15 12TH AVE RECOMMENDATION MEETING JOHNSON & CARR | S+HWorks

1715 12TH AVE DPD# 3019265

RECOMMENDATIONS MAY 22, 2015

VIEW FROM NORTHEAST

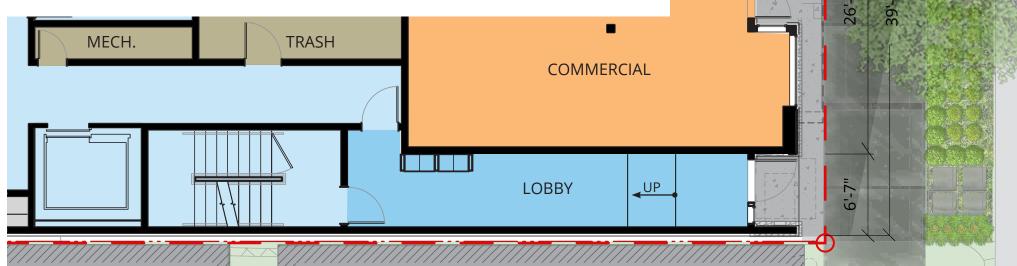
- · REFINE THE DESIGN TO PROVIDE DEFENSIBLE SPACE.
- · CONSIDER HOW TO VISUALLY CONNECT THE SPACE.
- RESIDENTIAL ENTRY

- CONSIDER THE RESIDENTIAL ENTRY, AND HOW IT RELATES TO THE PROPORTIONS OF THE OTHER ENTRIES.
- **BICYCLE CONNECTIONS**

CONSIDER ACCESS AND INTERNAL CONNECTIONS FOR BICYCLISTS.

- RECESSED ENTRY IS CLEARLY DELINEATED FROM SIDEWALK.
- SCALE OF ENTRY IS PERCEIVED AS PRIVATE AND RESIDENTIAL; DIFFERENTIATES FROM COMMERCIAL.
- MATERIALS, SIGNAGE, LIGHTING AND INTERIOR VIEW FURTHER DEFINE ENTRY.

- BIKE STORAGE IN BASEMENT, ACCESSED THROUGH LOBBY.
- OVERSIZED ENTRY DOOR TO MAKE ACCESS EASIER.

- 2 ADJACENT SITES & SETBACKS
 - LIGHT MATERIAL PALETTE ALLOWS FOR MORE AMBIENT LIGHT BETWEEN BUILDINGS.
- 3 ENTRIES & STREETSCAPE
 - RECESSED GATE ALLOWS FOR CORNER WINDOW IN COMMERCIAL SPACE.
 - GATE & FENCING ESTABLISHES DEFENSIBLE SPACE.
- 4 COMPOSITION & MATERIALS
 - PANEL PATTERN CREATES VISUAL INTEREST AT ZERO-LOT LINE CONDITION.
 - PERMEABLE MATERIAL ALLOWS FOR VISIBILITY AND SECURITY IN SIDE YARD.
 - EXTEND METAL PANEL ALONG NORTH ELEVATION TO ARTICULATE MASSING.

REAR YARD SECTION

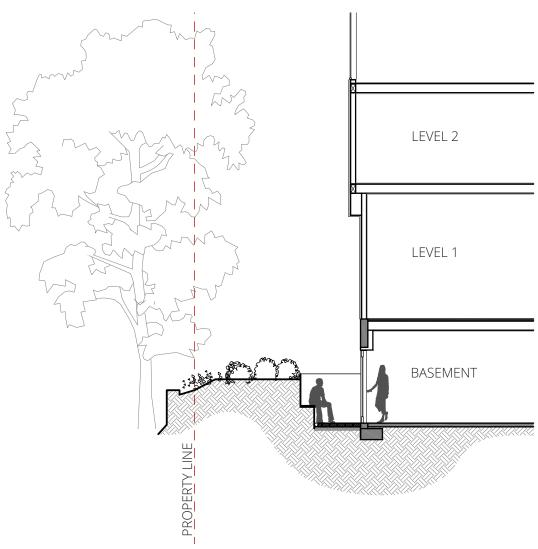
- · DESIGN THE WINDOW WELLS TO CREATE ACCESS TO VIEWS, LIGHT AND AIR.
- ROOF DECK AMENITY

- · HEIGHT OF WINDOW WELL MINIMIZED.
- SEATING INTEGRATED INTO WELL FOR AMENITY AND TO INCREASE DAYLIGHT.
- LOW PLANTING CREATES VISUAL INTEREST AND ALLOWS VISIBILITY.

- PLANTERS DIVIDE SPACE INTO MULTIPLE AREAS.
- · VIEWS MAXIMIZED TO THE WEST.

PRIVACY TO NORTH NEIGHBORS

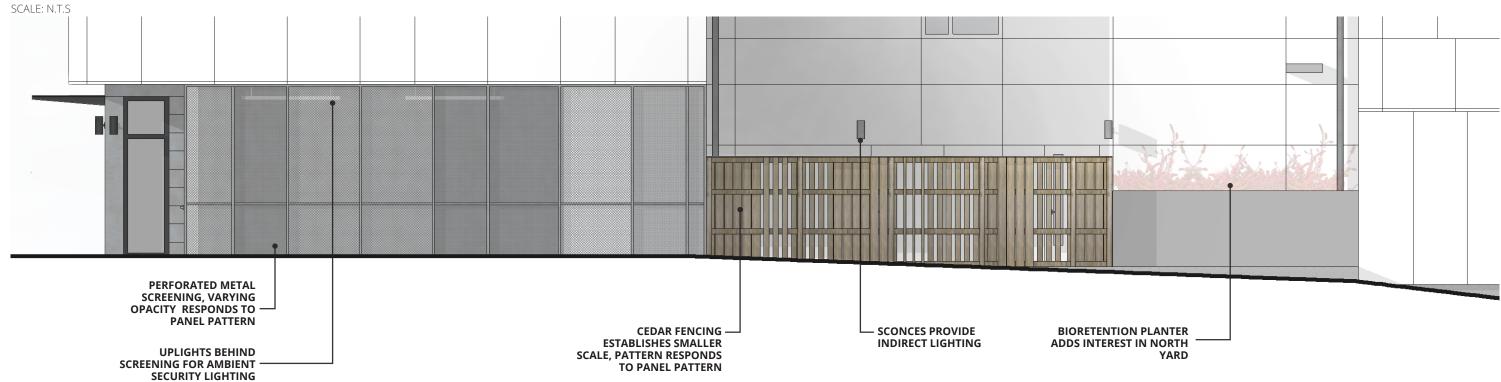
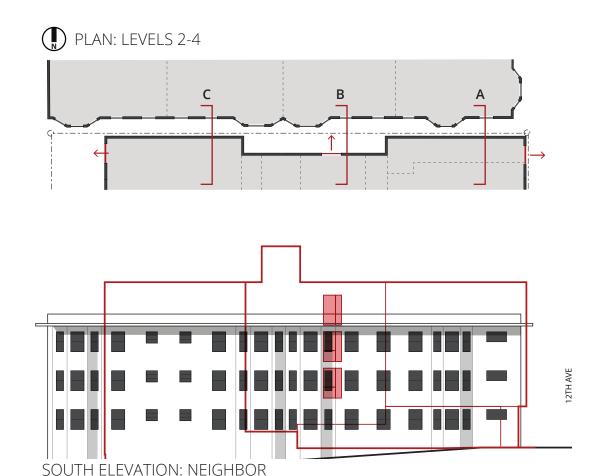
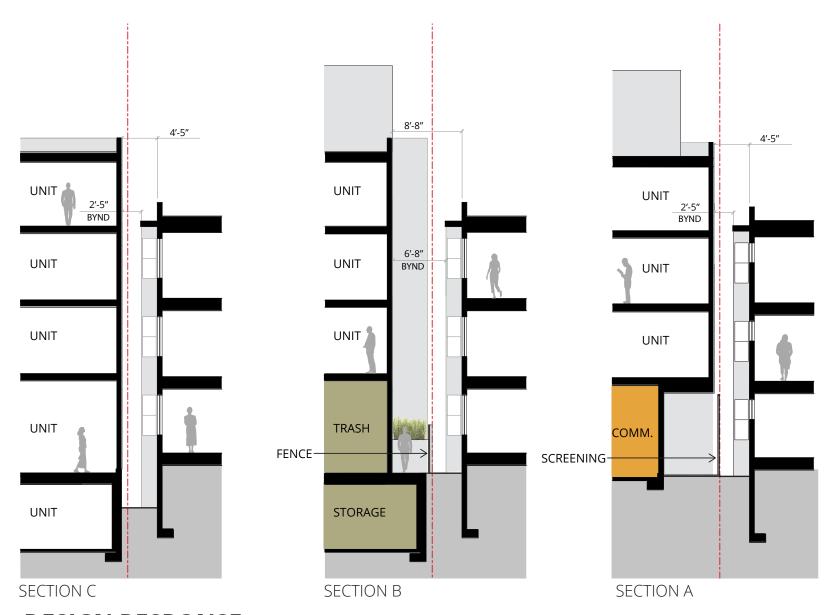
- MINIMIZE THE DISRUPTION OF PRIVACY FOR THE NORTH NEIGHBORS
- PROVIDE MORE INFORMATION ABOUT THE NORTH FACADE, INCLUDING OVERALL ARCHITECTURAL EXPRESSION AND VISUAL INTEREST.

- 1 MASSING
 - A LARGE LIGHT WELL IS ESTABLISHED AT THE CENTER OF THE BUILDING TO ALLOW MORE AMBIENT LIGHT AND SEPARATION TO NORTH.
 - · WEST MODULATION IS PULLED AWAY FROM NORTH PROPERTY LINE TO PROVIDE ADDITIONAL SEPARATION.
- 2 ADJACENT SITES & SETBACKS
 - 8'-8" SEPARATION AT LIGHT WELL, 4'-5" TYPICAL SEPARATION, 2'-5" SEPARATION AT MINIMUM.
 - · WINDOW OVERLAP OCCURS AT 8'-8" SEPARATION. INTERIOR CONFIGURATION GREATLY LIMITS PRIVACY CONFLICTS.
 - OFFSET GROUND FLOORS AND MASSING/WINDOW ADJACENCIES LIMIT OPPORTUNITY FOR PRIVACY CONFLICT AT NORTH WALKWAY.
 - · REAR YARD IS LIMITED TO LANDSCAPING AND PRIVATE PATIOS TO LIMIT NOISE IMPACTS.

- · LIGHT & BRIGHT PANEL FINISH MAXIMIZES REFLECTIVE LIGHT.
- PANEL PATTERN CREATES SUBTLE VISUAL INTEREST AND VARIETY FOR BLANK WALL CONDITION.
- SCREENING & FENCES INTENTIONALLY DESIGNED & TRANSITIONED TO LIMIT VISUAL CLUTTER FOR NEIGHBOR.
